ADDENDUM NO. 2

Issue Date:	January 17, 2024
Project Name:	Sandridge Golf Club New Clubhouse
ITB Number:	2024029
ITB Opening Date:	**February 1, 2024**

This addendum is being released to provide answers to questions received to date, modify the bid documents, provide additional background documents, and provide minutes to the pre-bid meeting.

SHEET NUMBER
A 411

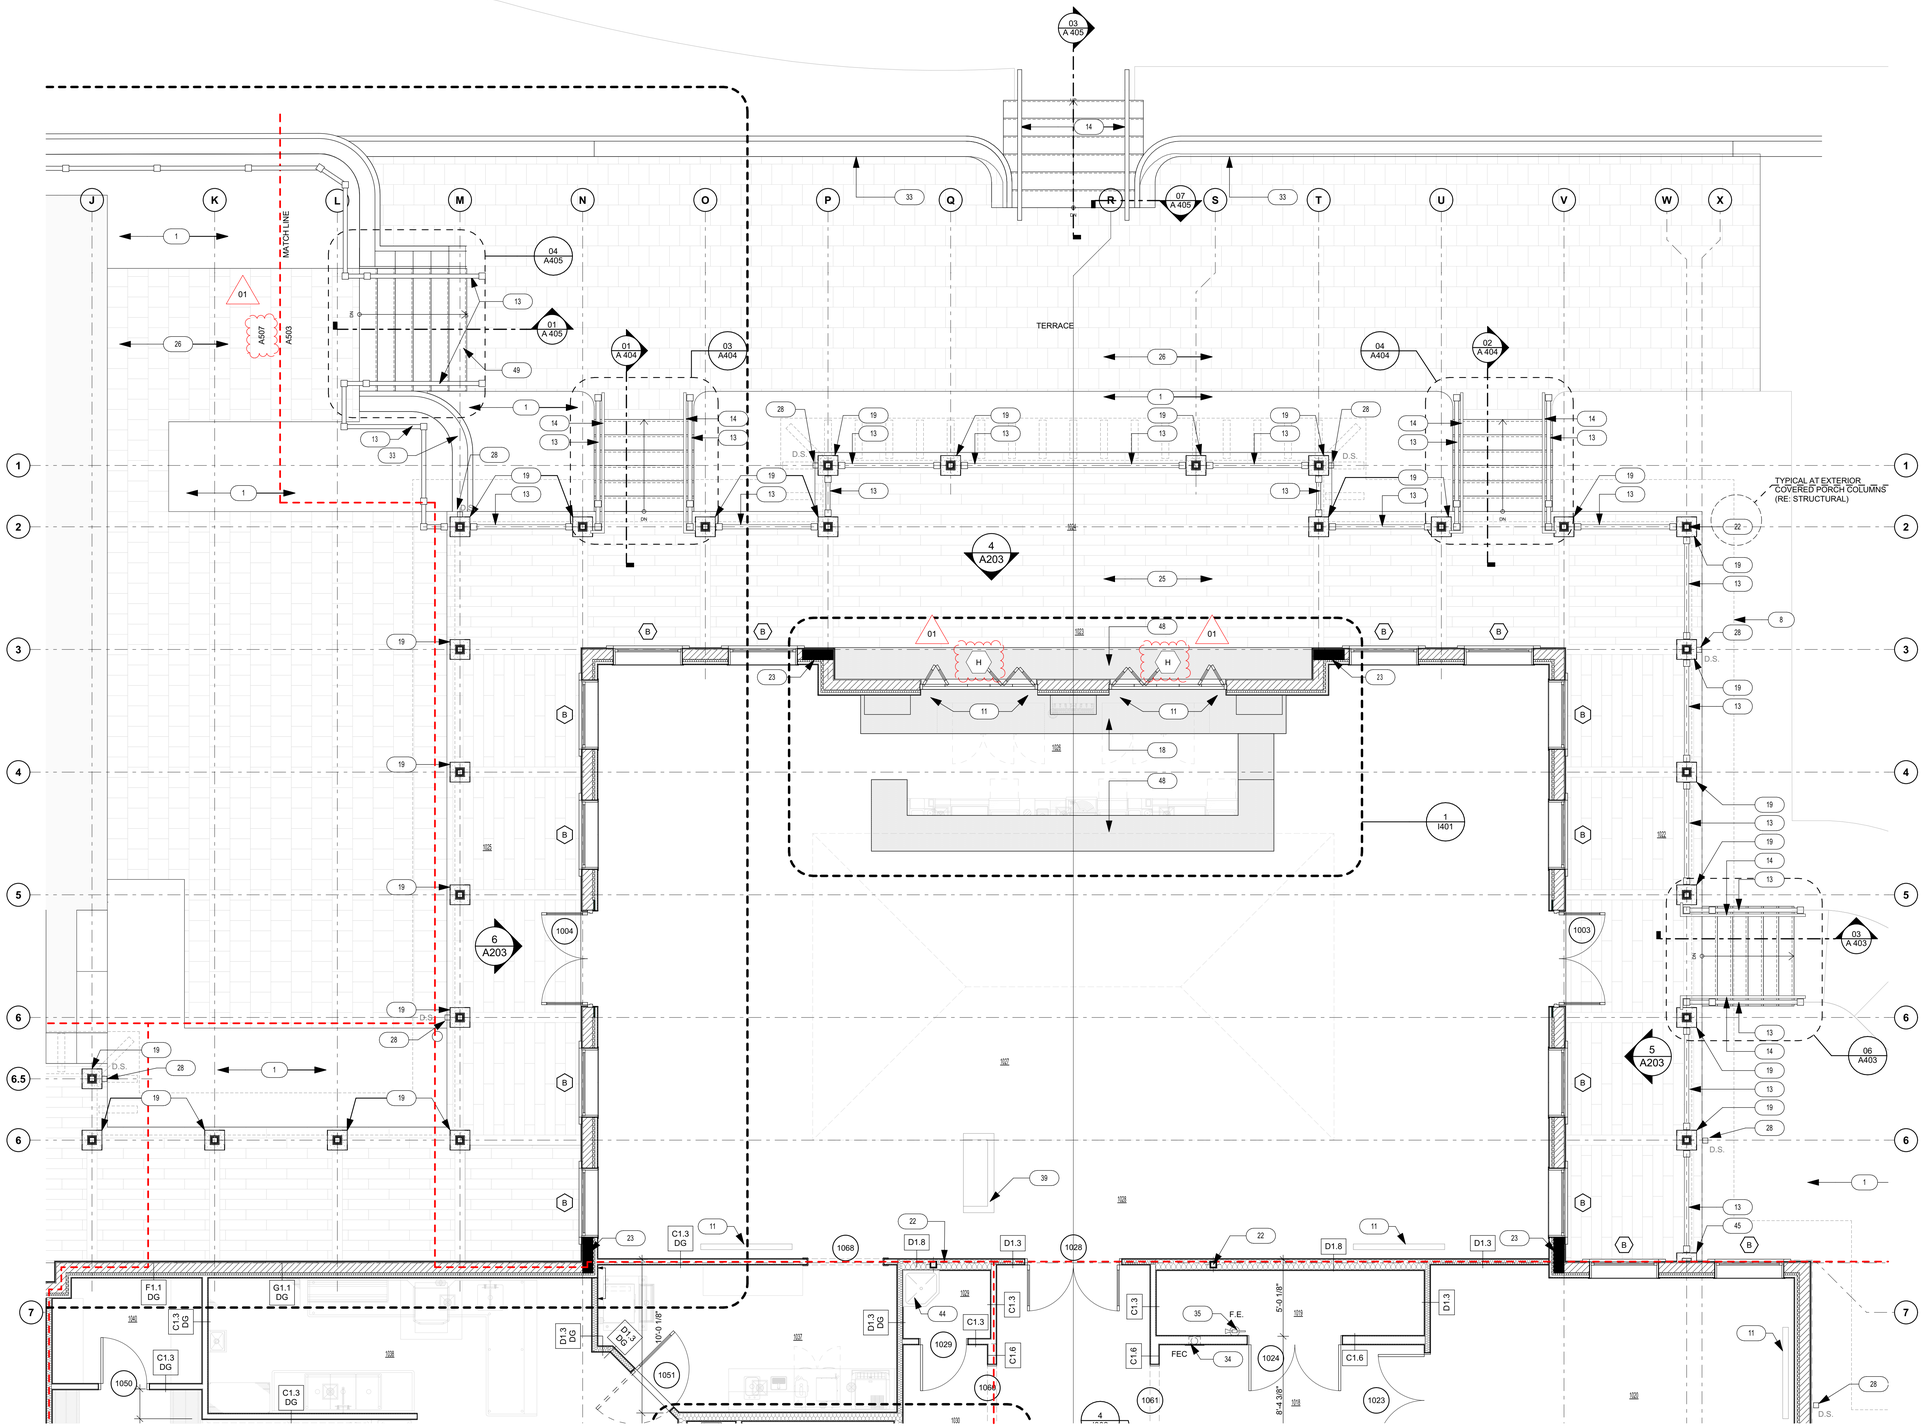
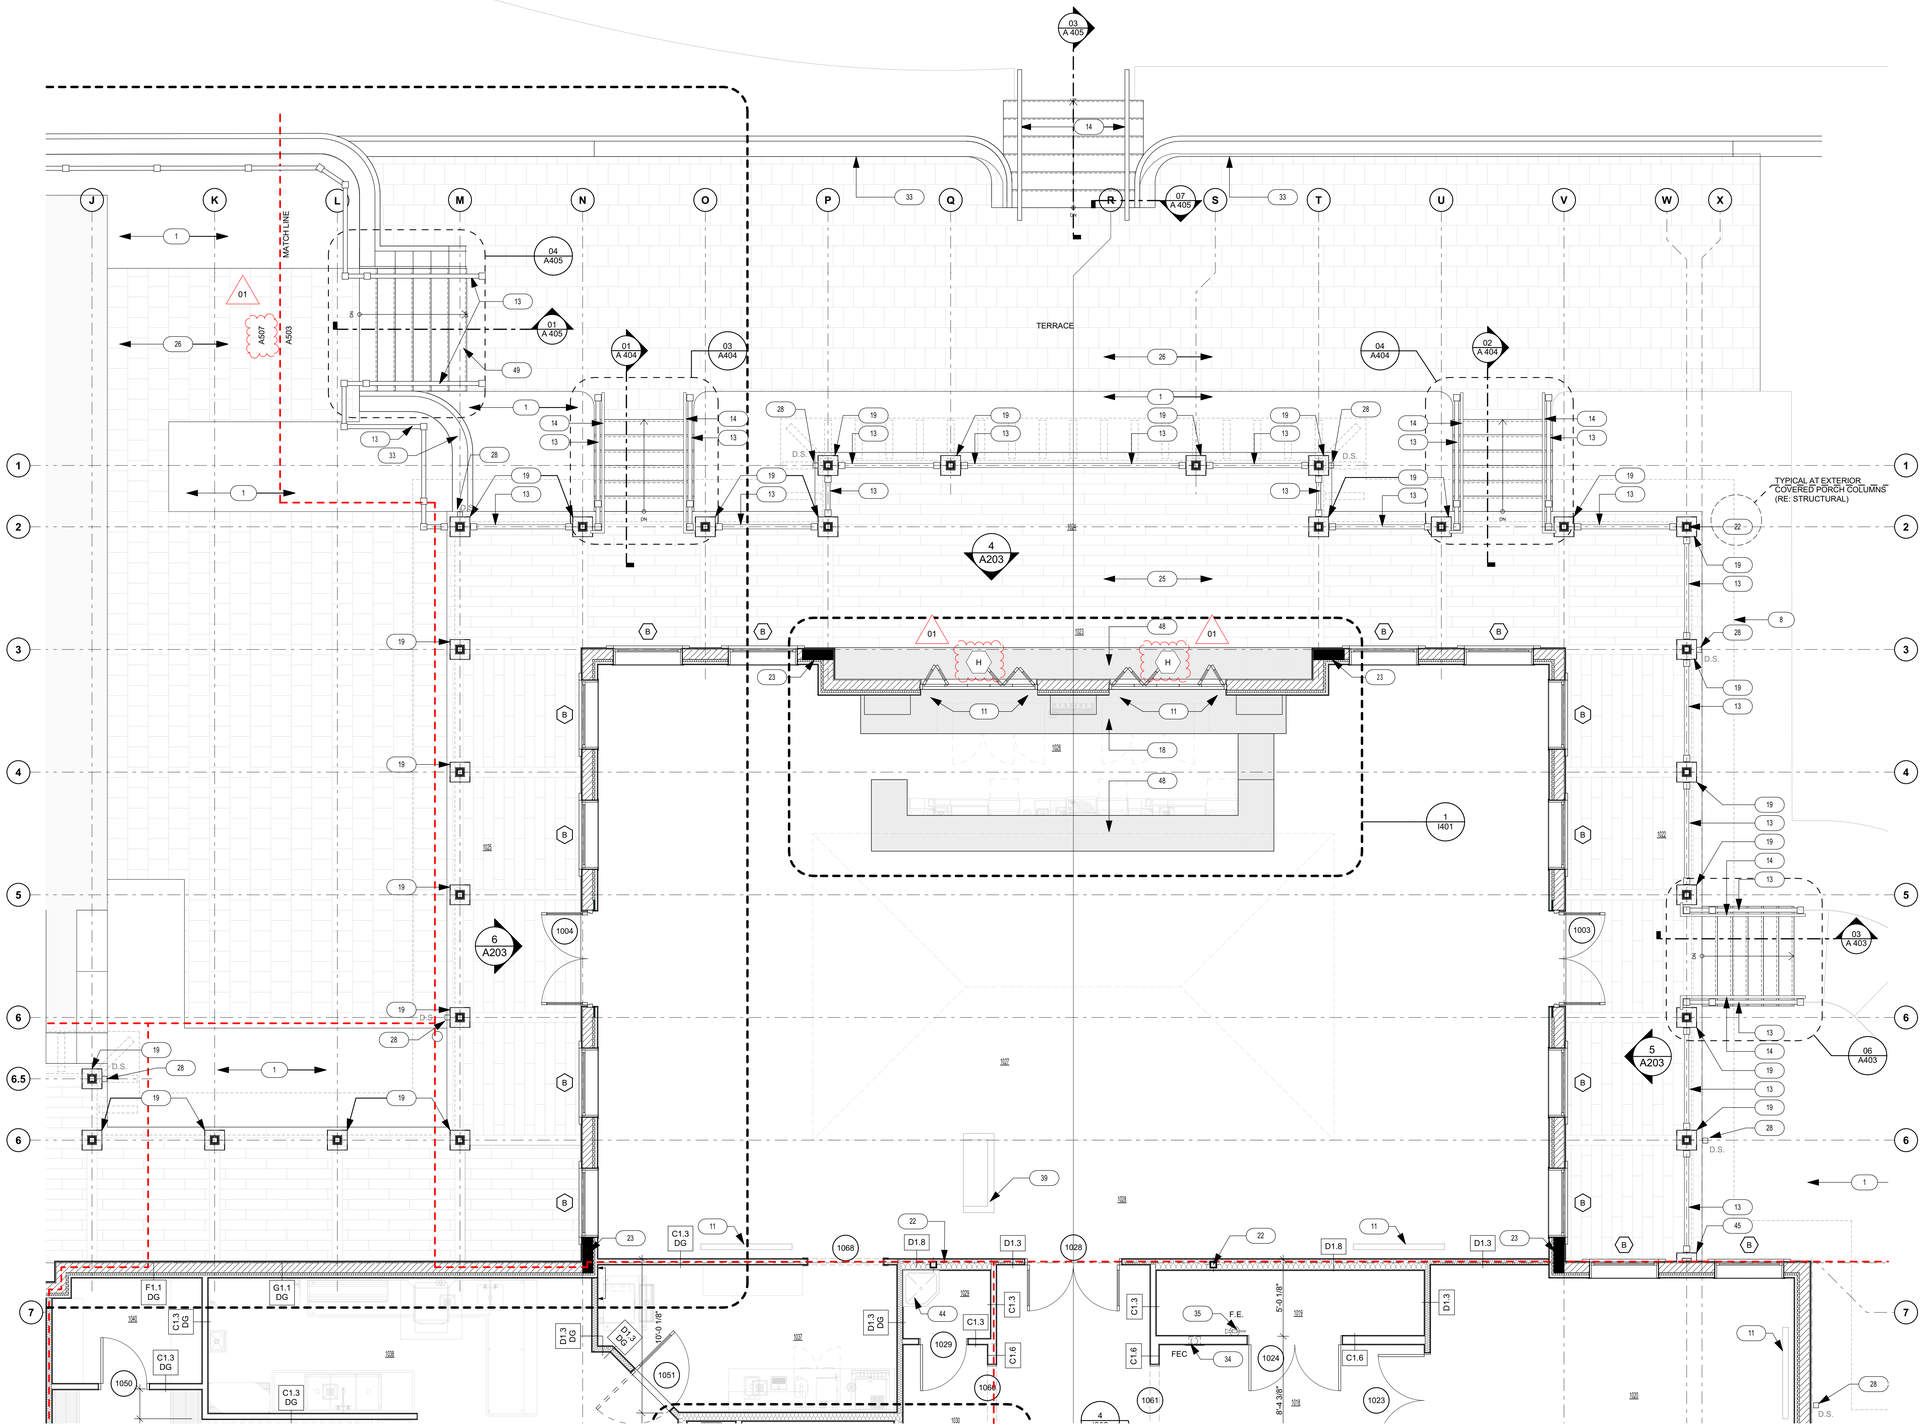
3. DRAWING A-503 WINDOW TYPE IS MARKED AS AN (E) I BELIEVE IT SHOULD BELABELED AS AN (H). ACCORDING TO THE WINDOW SCHEDULE. PLEASE VERIFY.
Confirmed, the window type mark is updated on Sheet A-503. See revised sheet.

12. SHEET A503 SHOWS A MATCHLINE PAGE A-510 THERE IS NO SUCH SHEET PLEASE ADVISE.
Matchline page A-510 is revised to A-507. See revised sheets A503 and A505 for clarification.
